REMARKS

AMENDMENTS TO THE DRAWINGS

FIG. 1

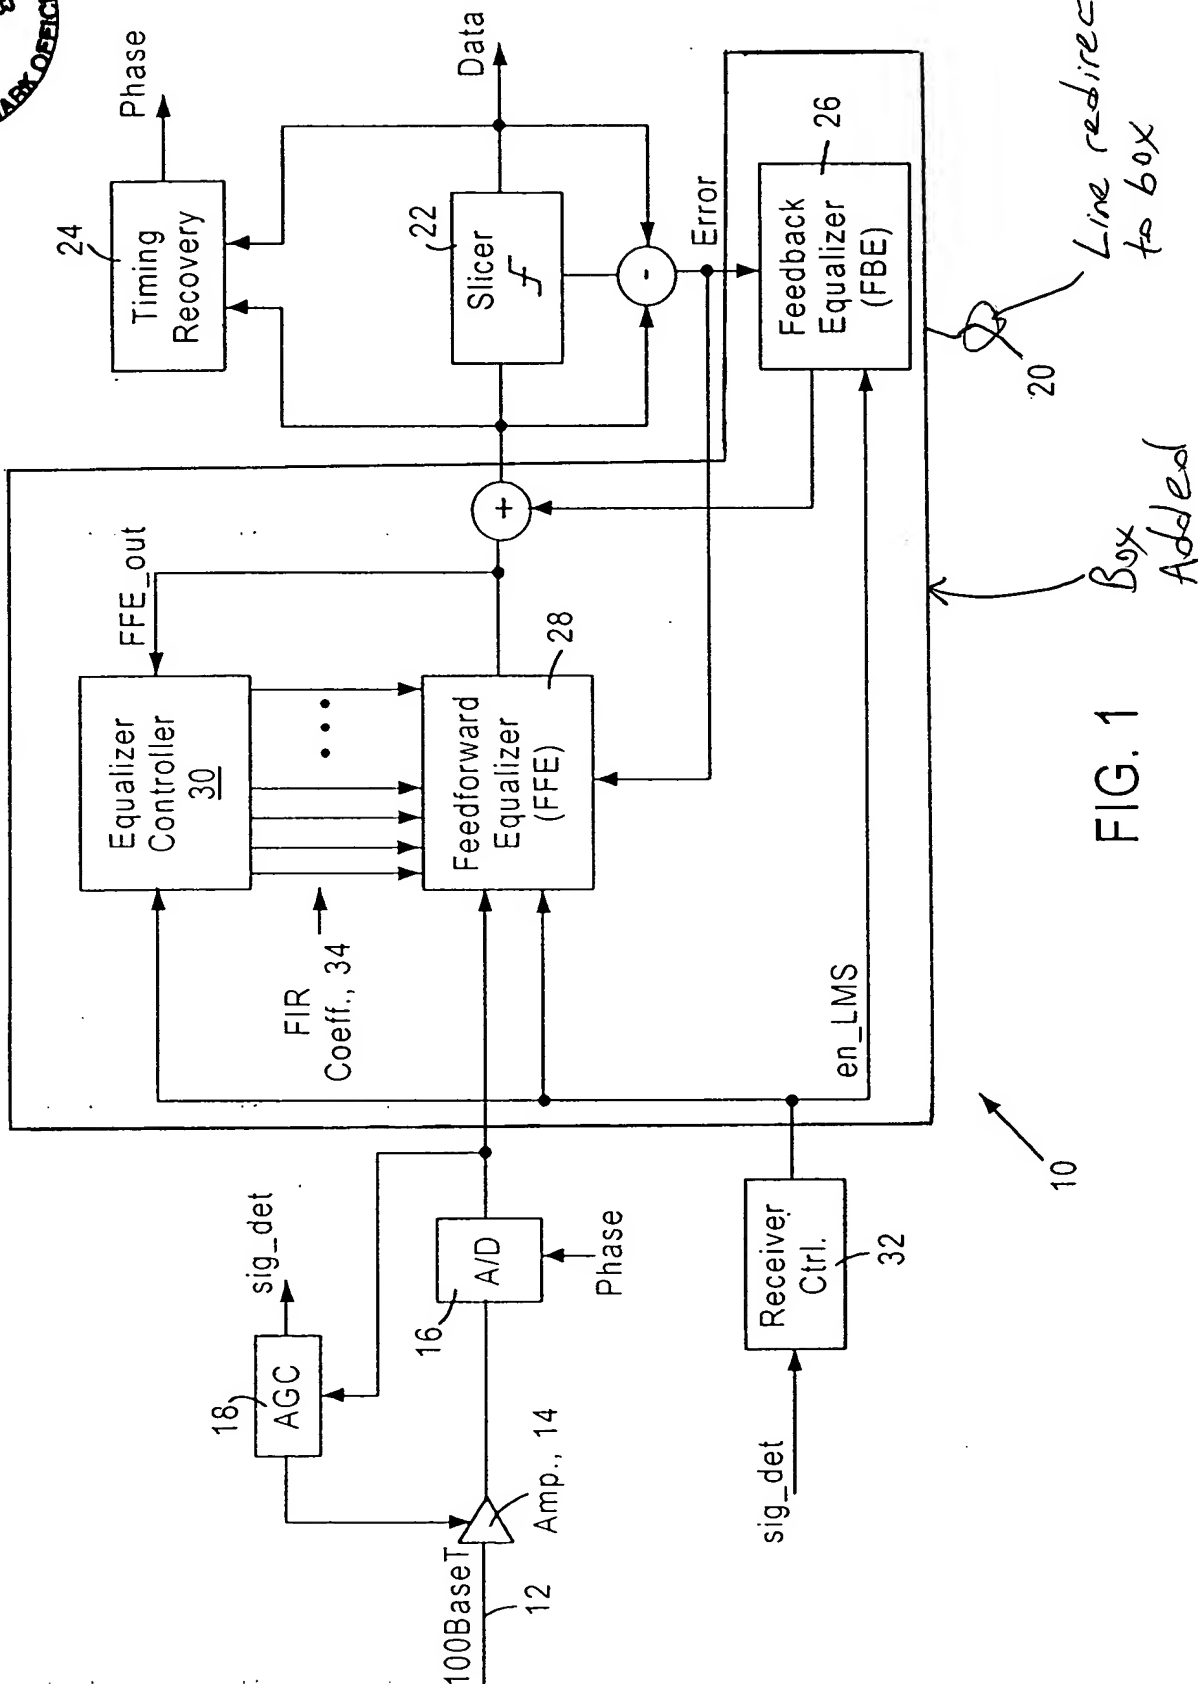
In Fig. 1, a box has been added to indicate that reference numeral 20 identifies the decision feedback equalizer circuit comprising elements 26, 28, 30 (see page 5, lines 28-29 of the specification).

Line redirected to box

Box Added

FIG. 2

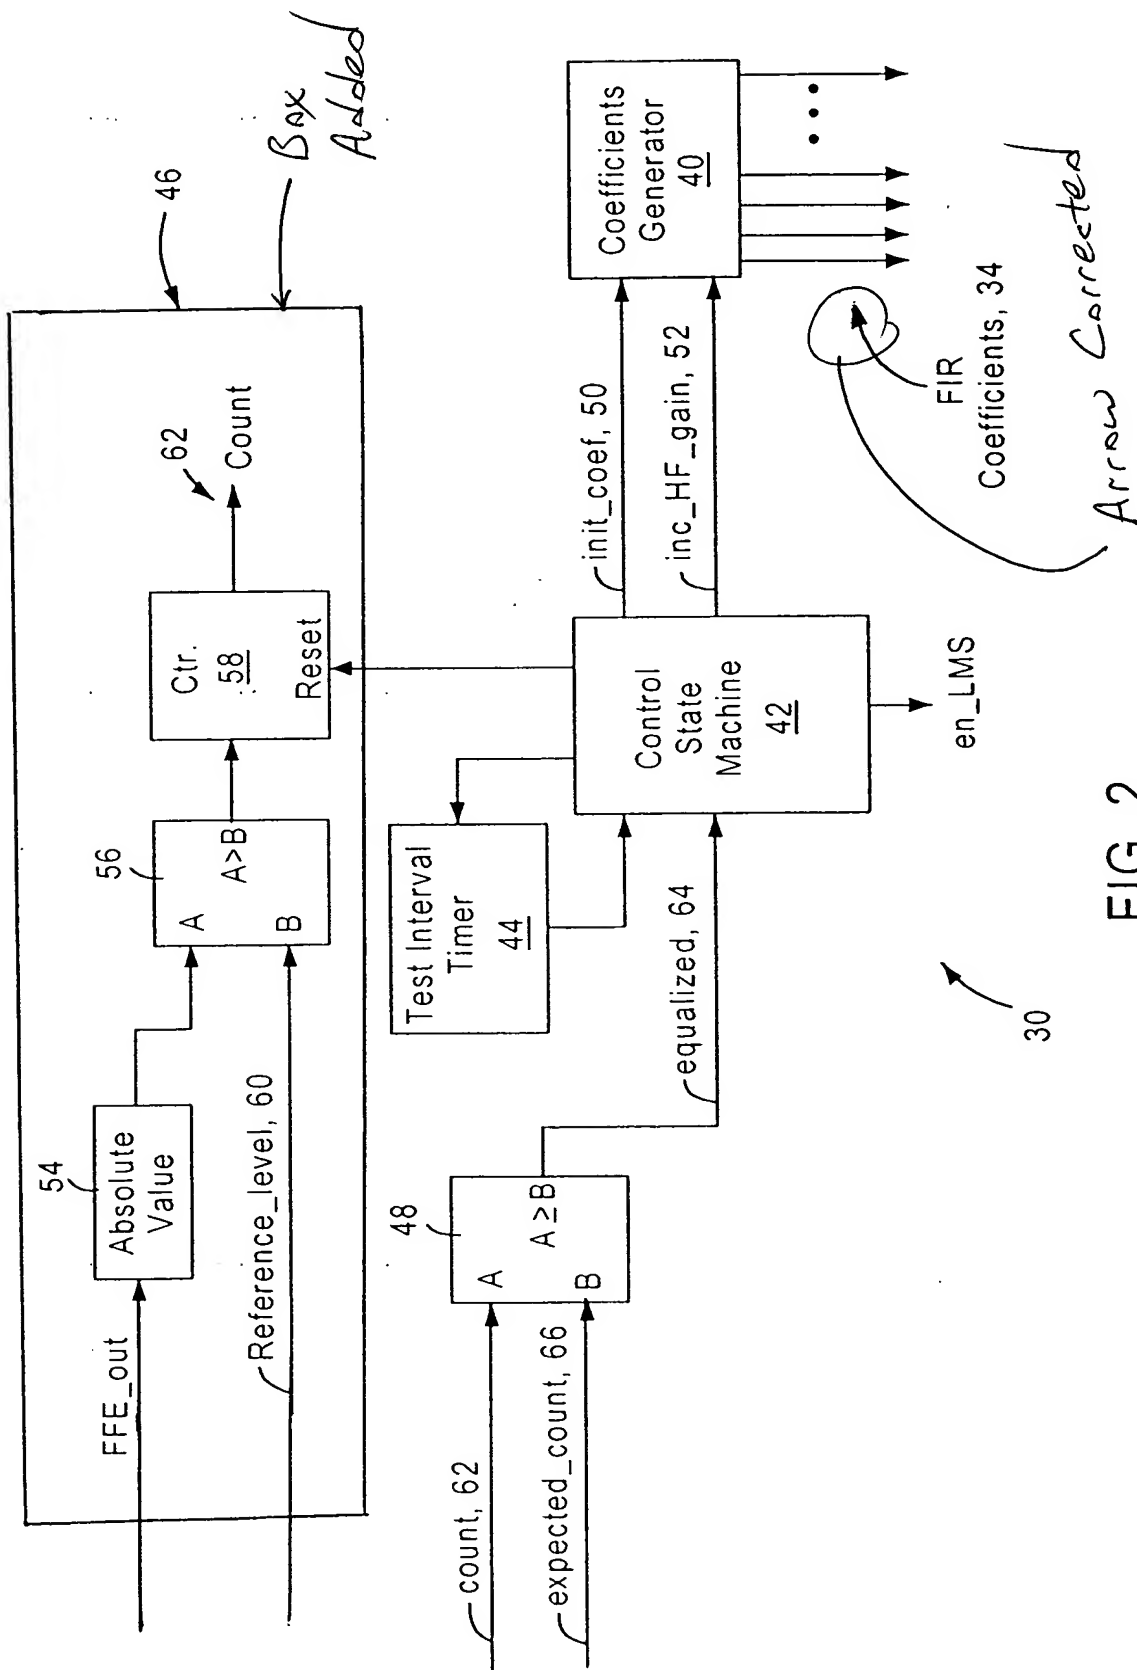
In Fig. 2, a box has been added to indicate that reference numeral 46 identifies the counter circuit comprising elements 54, 56, 58 (see page 7, line 12 of the specification), and the arrow for reference numeral 34 has been corrected.

FIG. 3

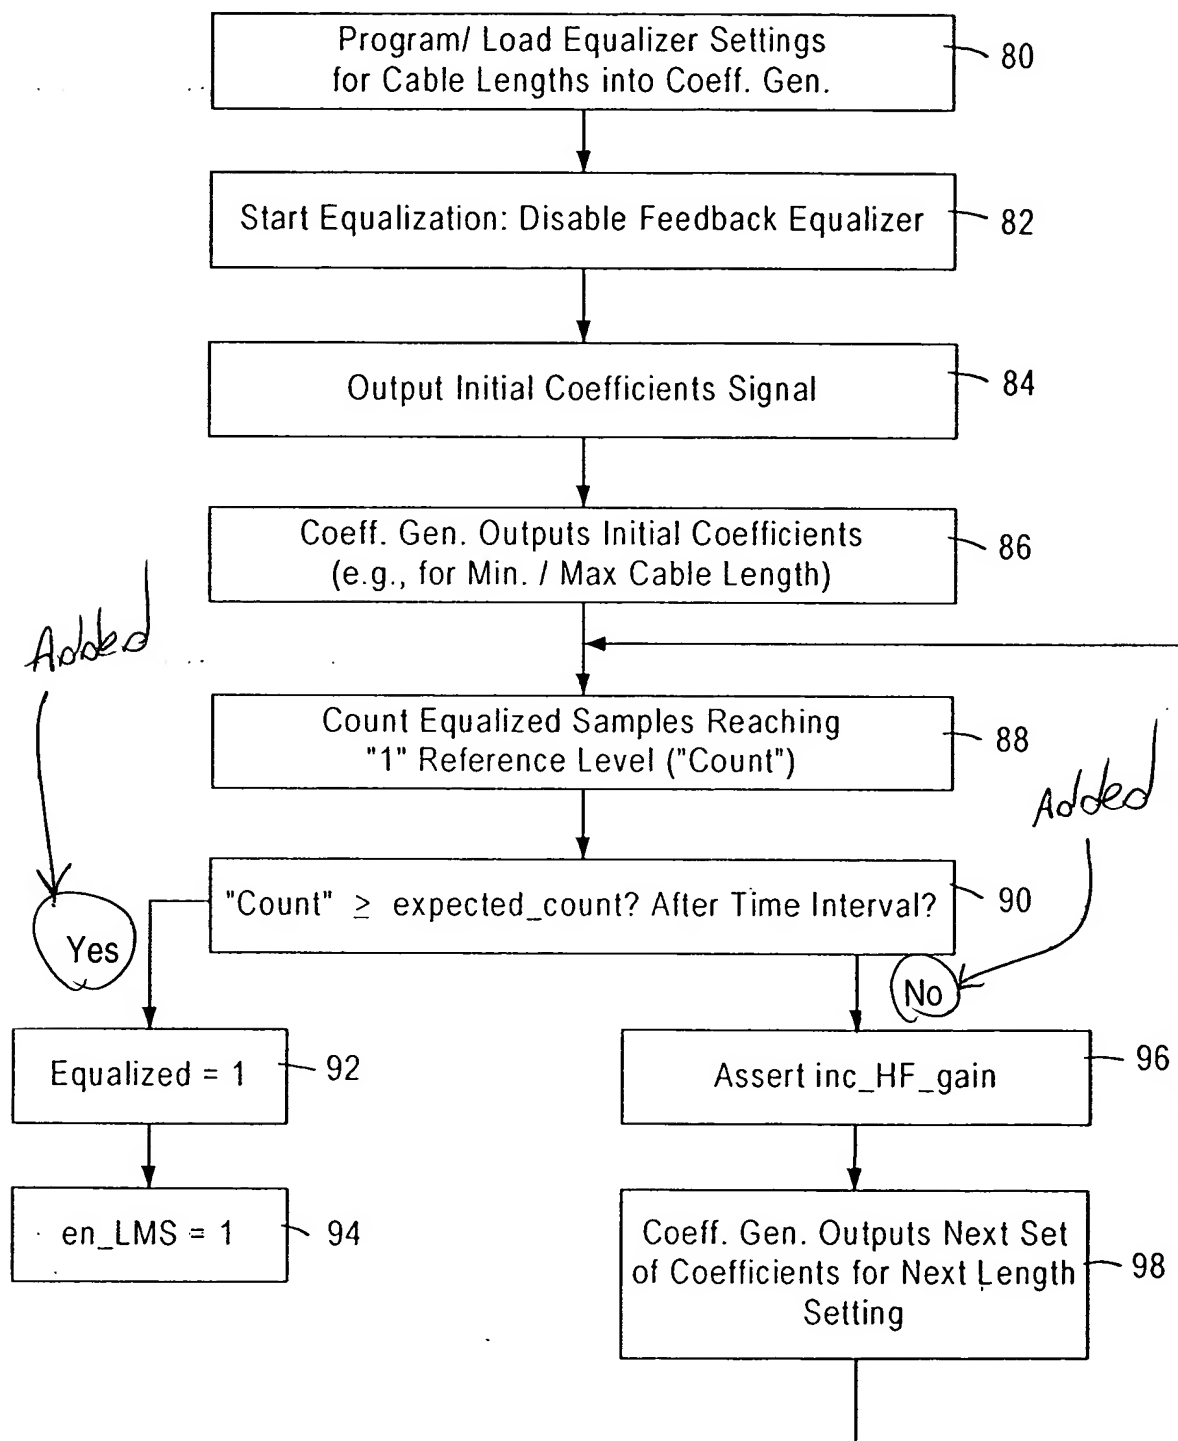
In Fig. 3, the decision labels "Yes" and "No" have been added with respect to step 90.
